MONTGOMERY COUNTY HISTORIC PRESERVATION COMMISSION
STAFF REPORT

Address:	29 Philadelphia Ave., Takoma Park	Meeting Date:	11/16/2022
Resource:	Contributing Resource Takoma Park Historic District	Report Date:	11/9/2022
Applicant:	Margaret Flaherty (Christian Lopez, Agent)	Public Notice:	11/2/2022
Review:	HAWP	Tax Credit:	n/a
Permit No.:	1011214	Staff:	Dan Bruechert
Proposal:	Fenestration and Hardscape Alteration

Figure 3: 1959 Sanborn Fire Insurance Map, showing basement automobile storage.

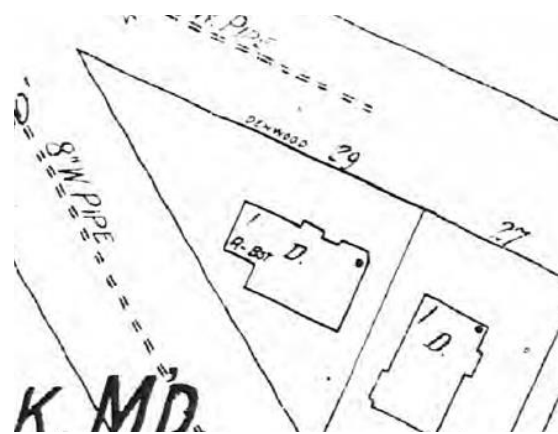
Staff's initial impression upon visiting the site was that the house had been modified to accommodate the garage door. That impression was likely due to the proportions of the garage itself and because the retaining wall changes from stone to concrete at the driveway. Staff reviewed the Sanborn Fire Insurance Maps for the property. The 1927 map did not show a garage (typically marked with an "A" for automobile) at the subject property. The notations for the 1959 map show there is auto storage at the basement level. Unsure if a basement garage was a novelty in 1927, Staff reviewed other Sanborn maps and identified five instances of basement-level auto storage. Having determined that the existing garage is not an original feature of the house, Staff recommends the HPC approve the removal of the garage door under 24A-8(b)(1) and Standard 2. Additionally, the proposal does not run afoul of the *Guideline* that encourages the retention of the original window and door size and shape.

Staff additionally finds the proposed stuccoed CMU wall is in keeping with the style and materials of the house and recommends the HPC approve the garage door removal and wall replacement. Discussion of the proposed window continues below.
